3 August 2010

**SECTION 75W MODIFICATION – MP08_0238
88 WALKER STREET, NORTH SYDNEY**

Figure 2 – Wind mitigation measures for proposed development

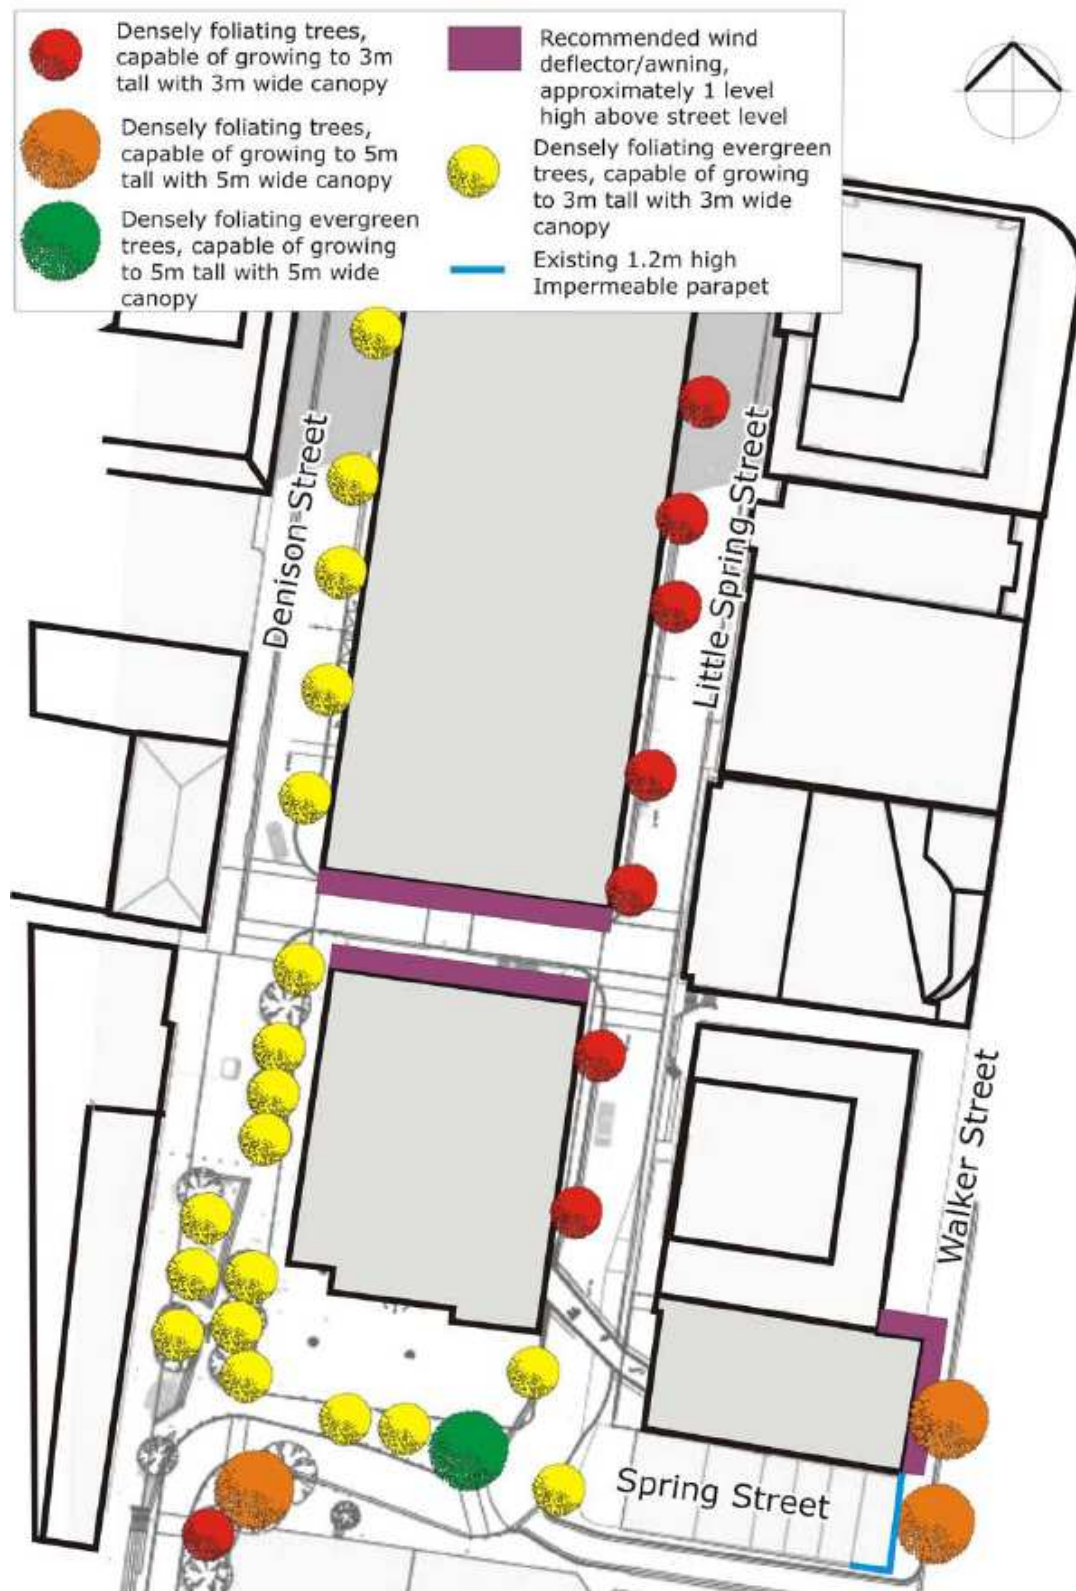
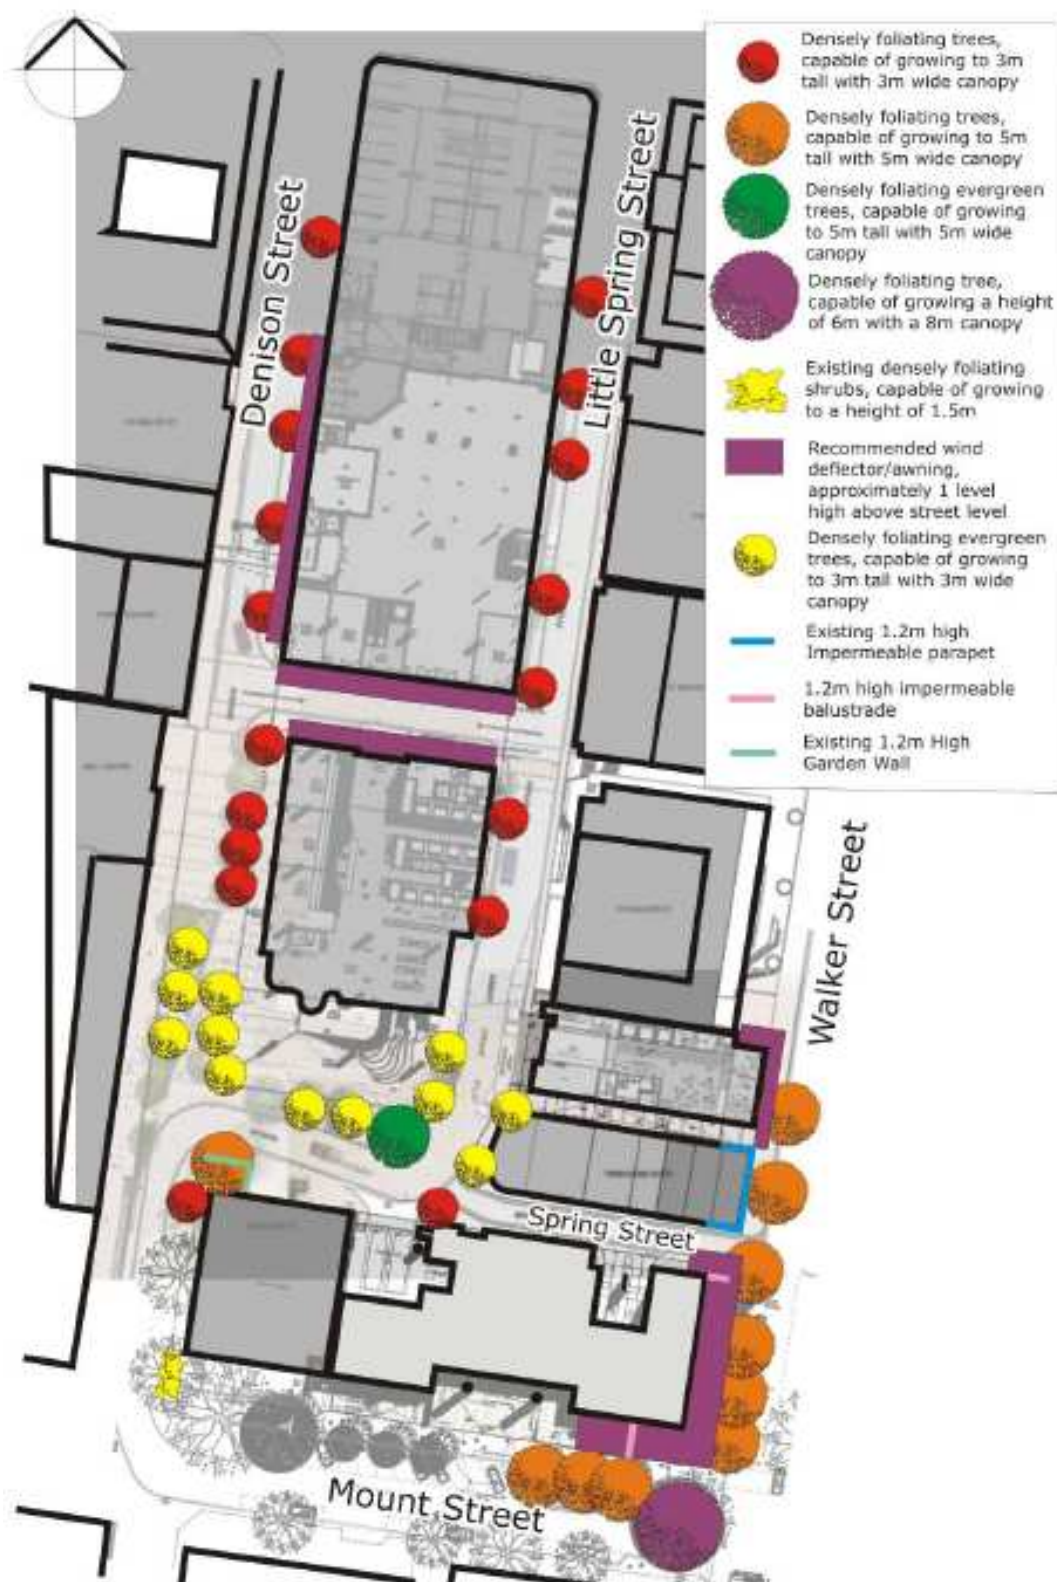
As can be seen in **Figures 1** and **2** generally the same mitigation measures are recommended with the exception of the trees to be planted in Denison Street. Windtech now recommend that 9 densely foliating trees, capable of growing to 3m tall with a 3m wide canopy be planted along the northern section of the street.

With the wind mitigation measures implemented, Windtech are of the opinion that all trafficable outdoor areas within and around the development site will satisfy the appropriate wind comfort criteria. Wind conditions for all areas will also be similar to, or better than, the existing wind conditions for the ground level areas.

Figure 4 – View cones under the proposed development

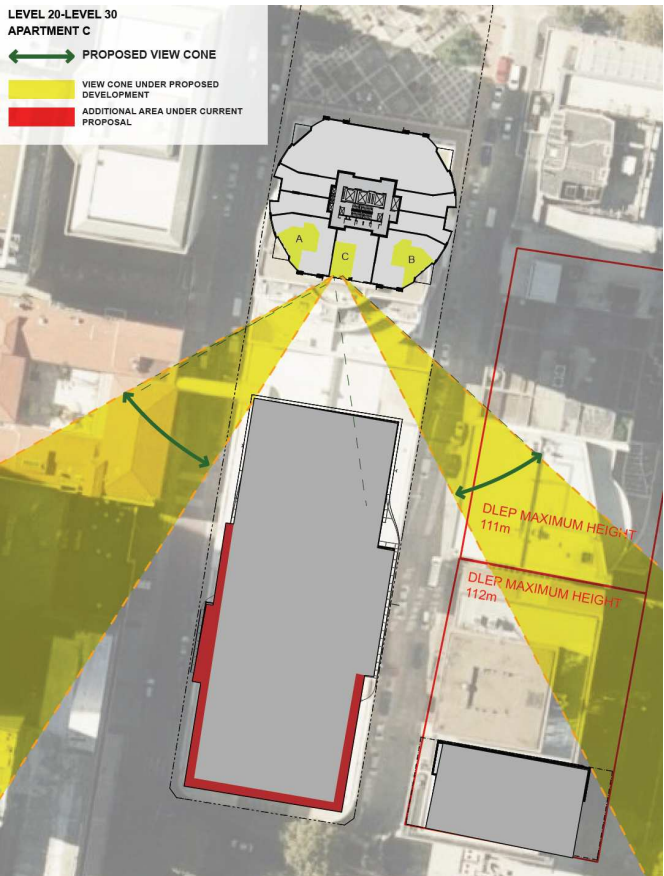
As can be seen in the images, the changes to the built form do not result in any additional loss of an iconic view or water view. As the changes to the building setbacks are only made at the southern portion of the building, they do not affect the view cone that the Beau Monde Apartments would retain if the building was constructed as currently approved. This is demonstrated in **Figures 3** and **4** which provide a comparison of the view corridor of the approved building and the revised building envelopes.
